Serial: NPD-NRC-2009-114
June 23, 2009

**LEVY COUNTY NUCLEAR POWER PLANT, UNITS 1 AND 2
DOCKET NOS. 52-029 AND 52-030
RESPONSE TO REQUEST FOR ADDITIONAL INFORMATION LETTER NO. 045 RELATED TO
PROBABLE MAXIMUM FLOOD (PMF) ON STREAMS AND RIVERS**

**Levy Nuclear Power Plant Units 1 and 2
Response to NRC Request for Additional Information Letter No. 045 Related to
SRP Section 2.4.3 for the Combined License Application, dated May 19, 2009**

FIGURE 3

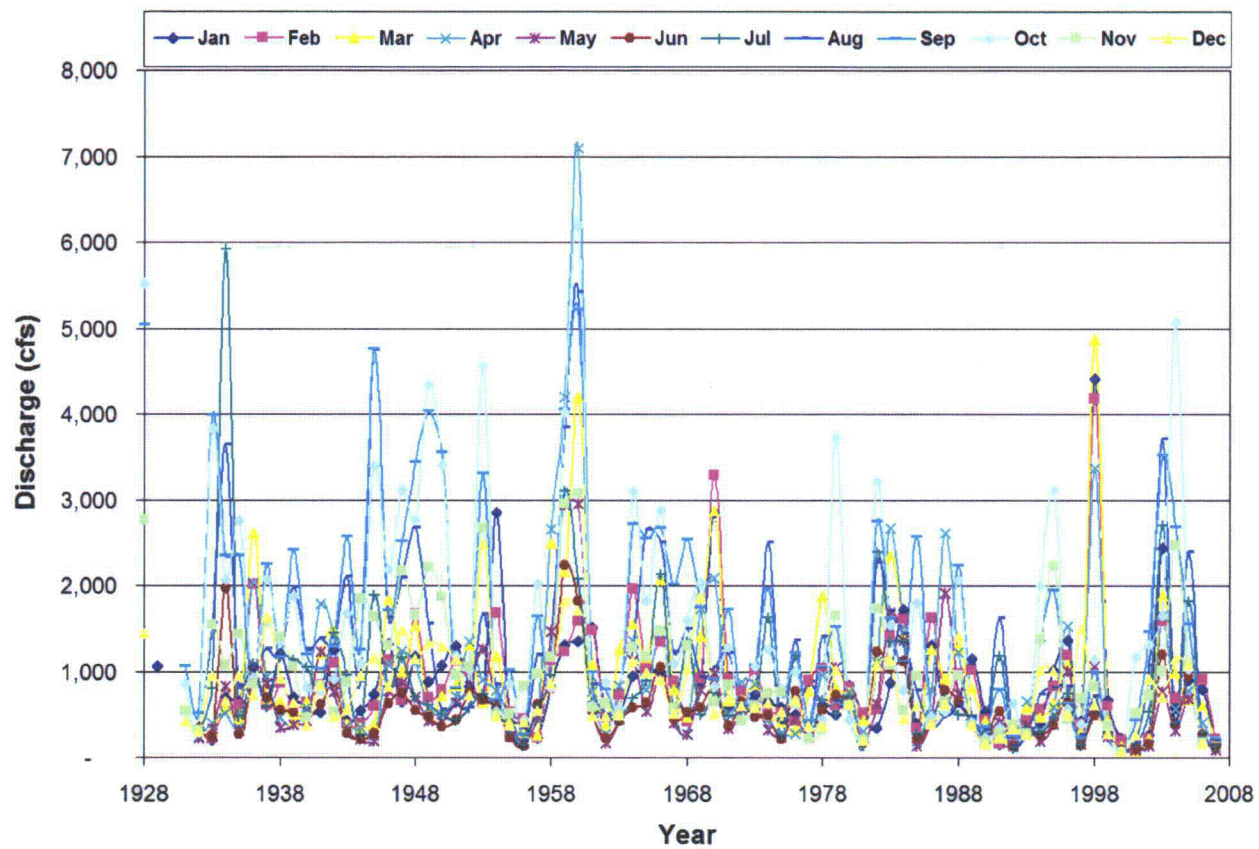
To meet the requirements of GDC 2, 10 CFR 52.17, and 10 CFR Part 100, estimates of the following characteristics are needed, and should be based on conservative assumptions of hydrometeorologic characteristics in the drainage area: (a) the area of the watershed used to estimate flooding in streams and rivers, (b) the total depth of PMP and the PMP hyetograph, (c) the maximum PMF water surface elevation in streams and rivers with coincident wind-waves, and (d) hydraulic characteristics that describe dynamic effects of PMF on SSC important to safety. Please clarify the estimation of base flow used in the determination of the PMF discharge.

An inspection of Figure 2 shows the mean monthly flow for the months of August, September, October, and November are higher than the base flow used in the hydrologic modeling. In order to determine the impact of these higher monthly base flows, a sensitivity analysis was conducted. The results of the sensitivity analysis are presented in Table 2 and on Figure 3 (Results of the Sensitivity Analysis - Impact of Base flow on the PMF Elevation). Based on these results, it can be concluded that the impact of the higher monthly base flow on the PMF elevation is insignificant since it would increase the PMF level by less than 0.02 foot.
